ADDENDUM NUMBER 5

- 1.01 DATE: DECEMBER 23, 2020
- 1.02 PROJECT: ELMORE SPORTS MEDICINE RENOVATIONS
- 1.03 PROJECT NUMBER: DCM NO. 2020452; PSCA NO. 2018
- 1.04 OWNER: ALABAMA A&M UNIVERSITY
- 1.05 ARCHITECT: NOLA | VAN PEURSEM ARCHITECTS, PC

SHEET NUMBER
M-1
OF
4

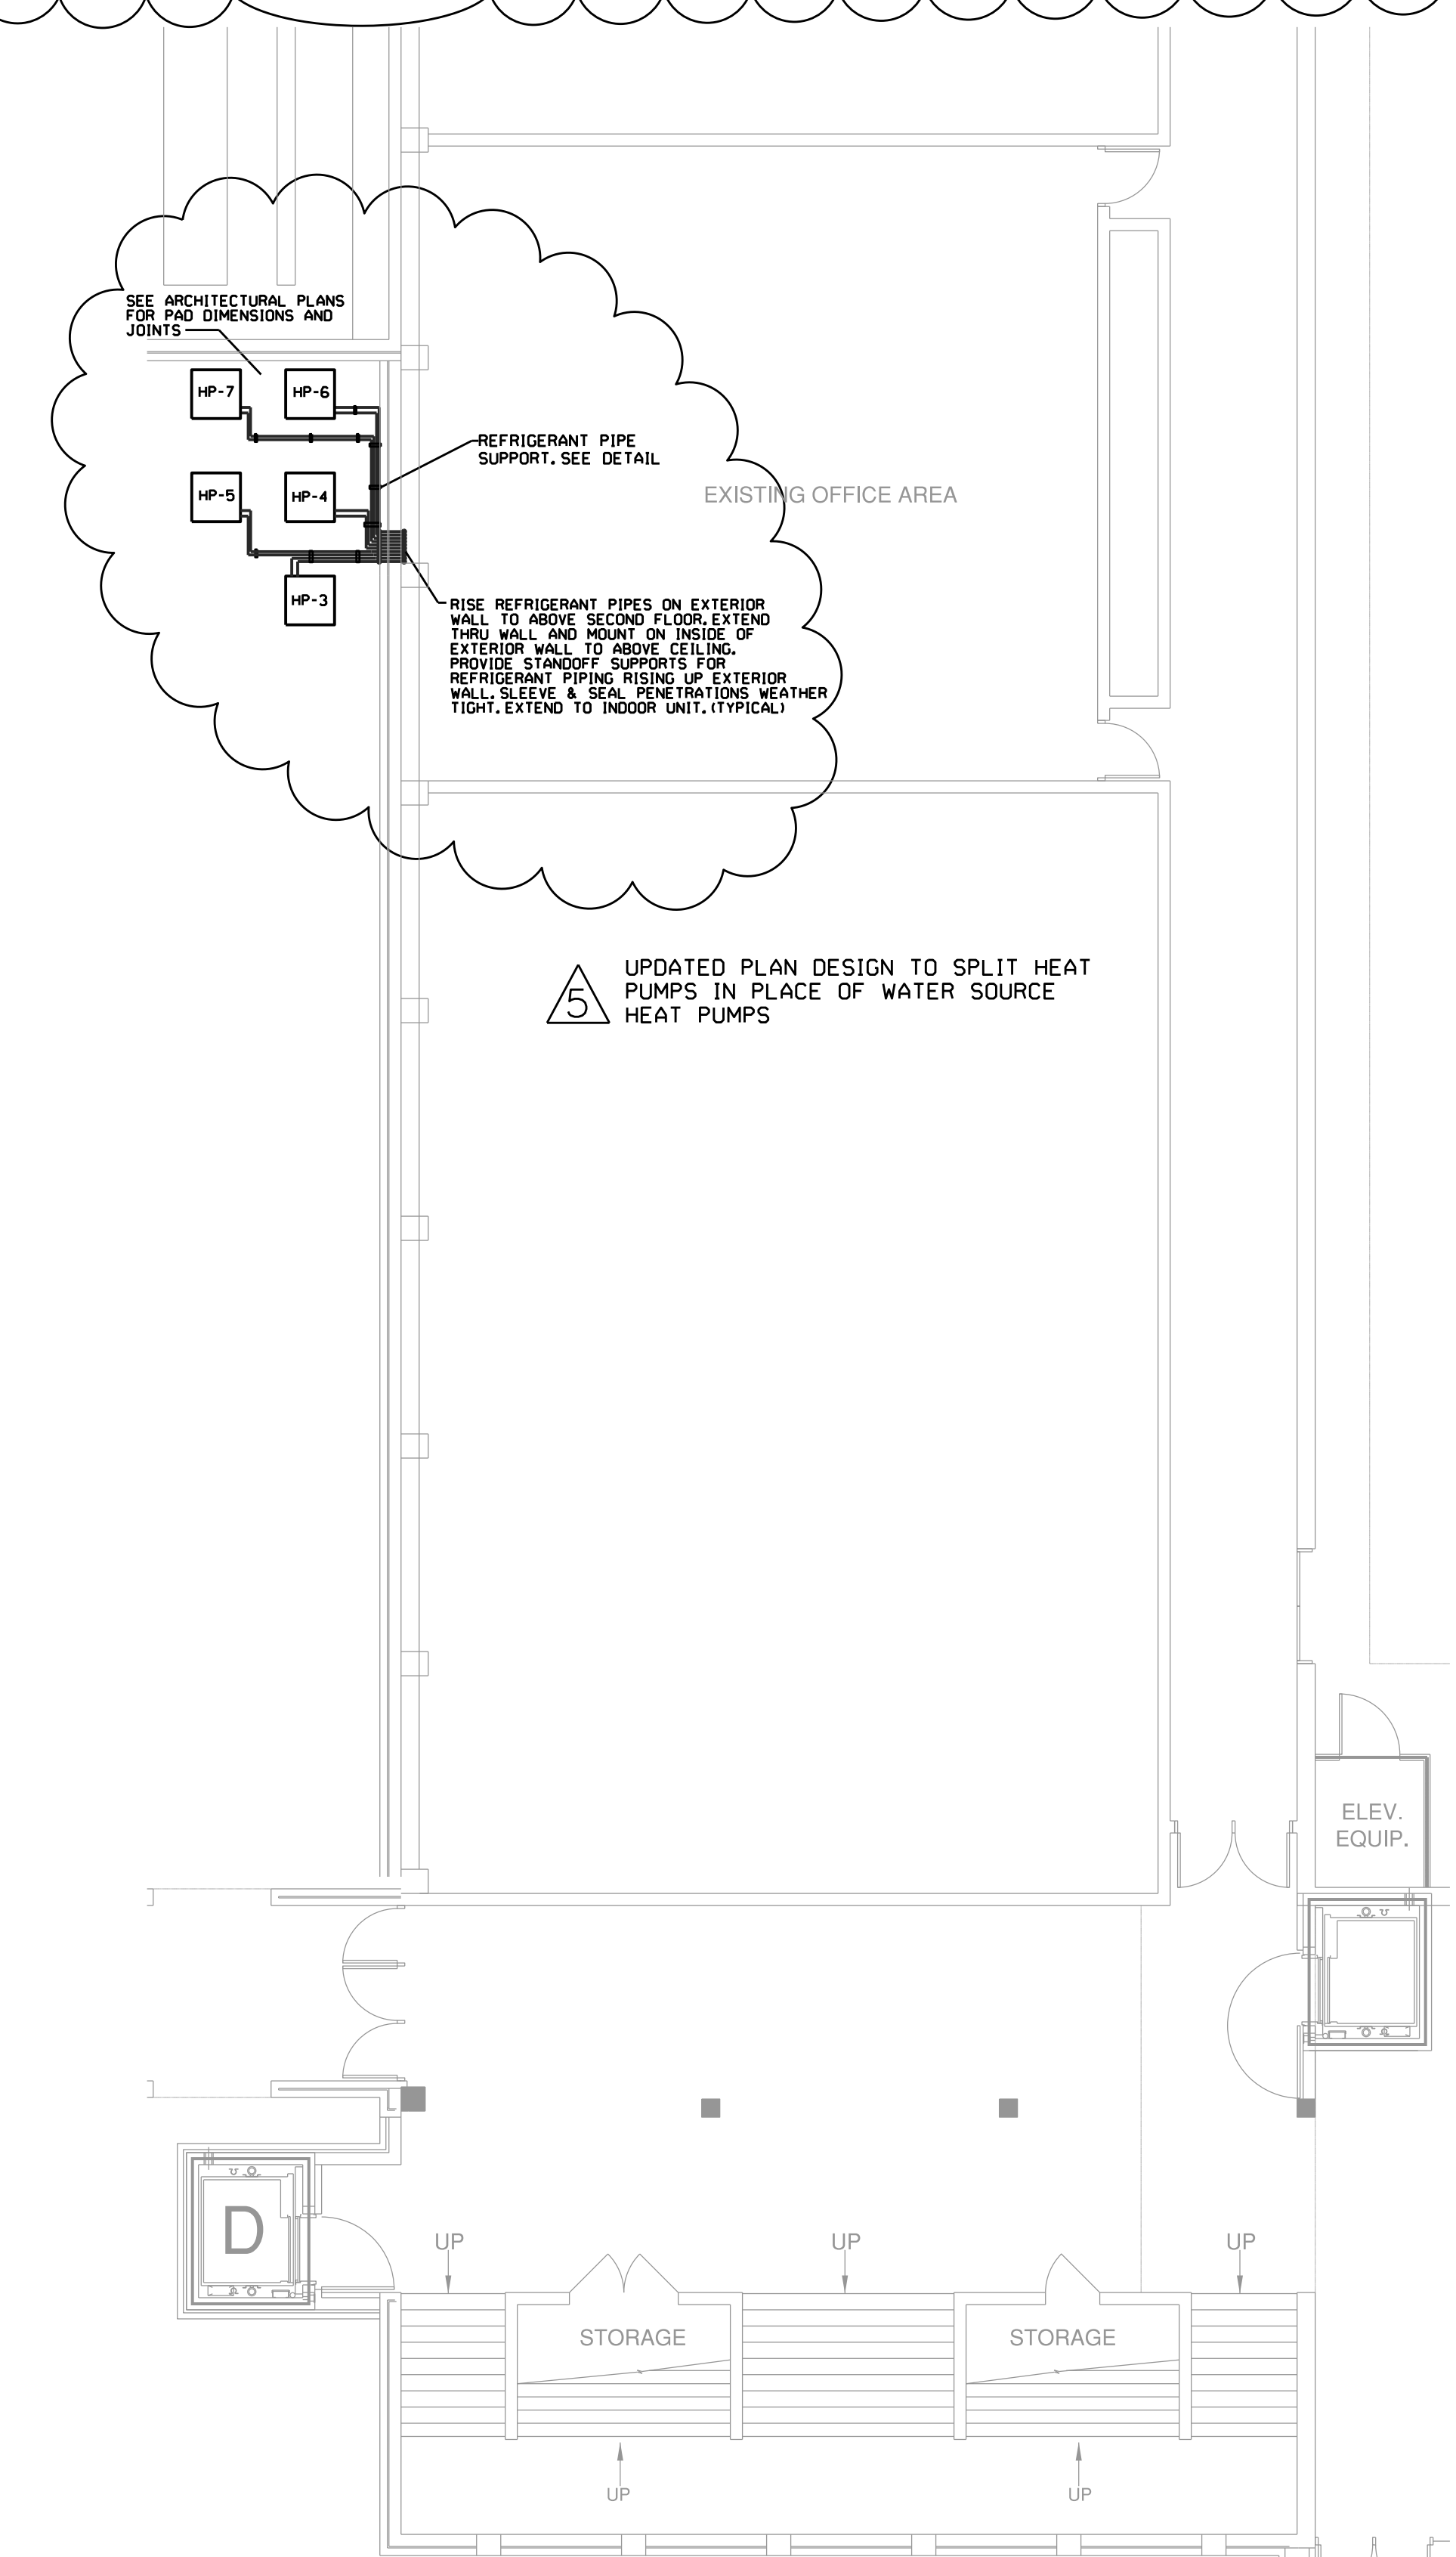
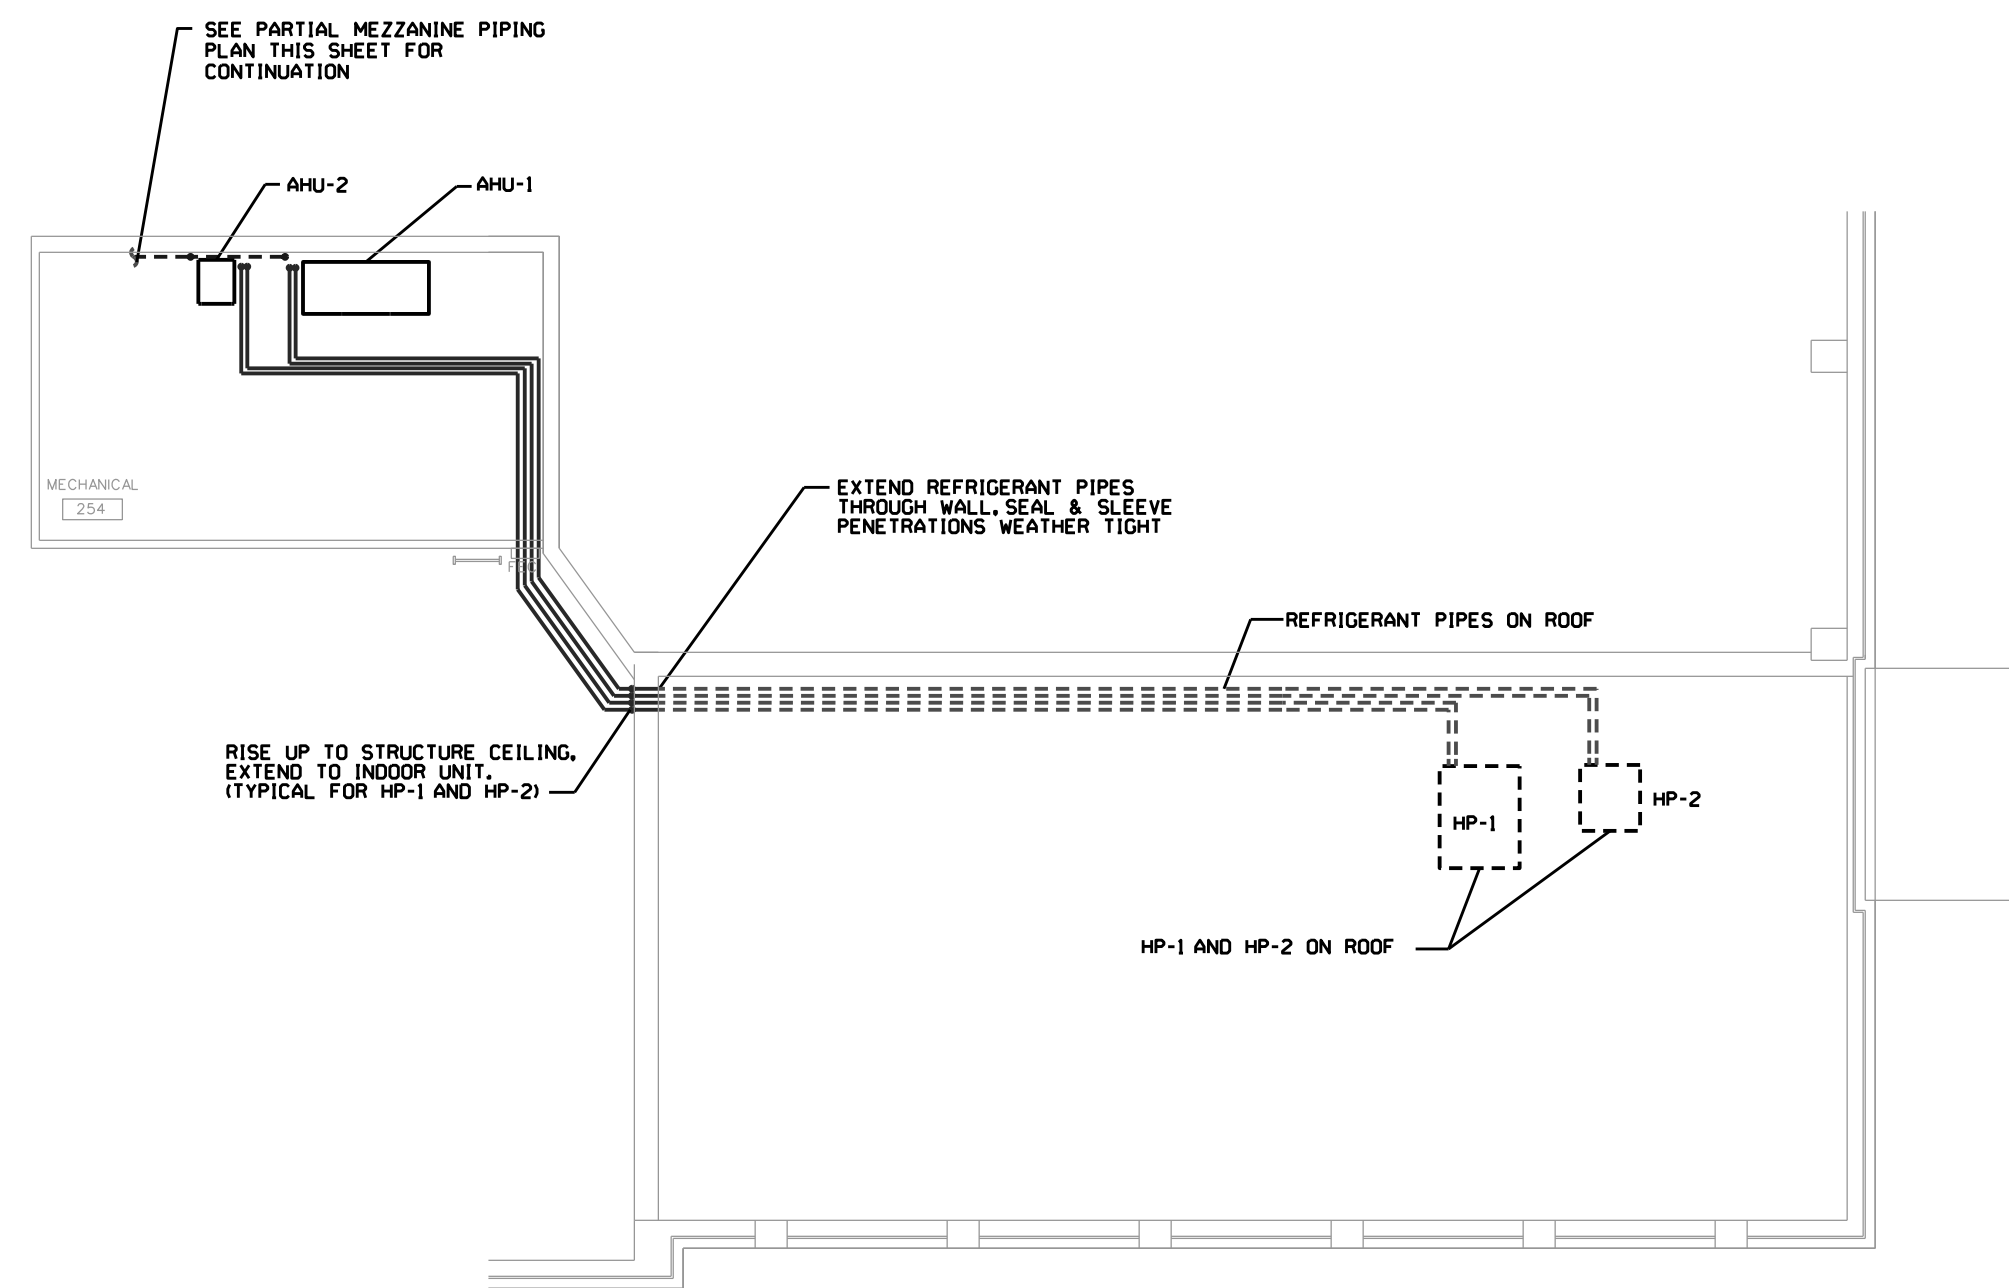
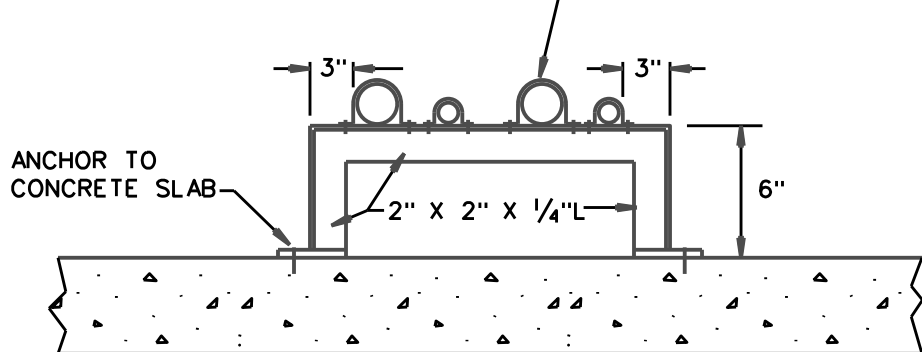
4.02 SHEET M-1 – MECHANICAL FLOOR PLAN:

A. Replace this sheet in its entirety to reflect revised mechanical system.

UPDATED PLAN DESIGN TO SPLIT HEAT PUMPS IN
PLACE OF WATER SOURCE HEAT PUMPS
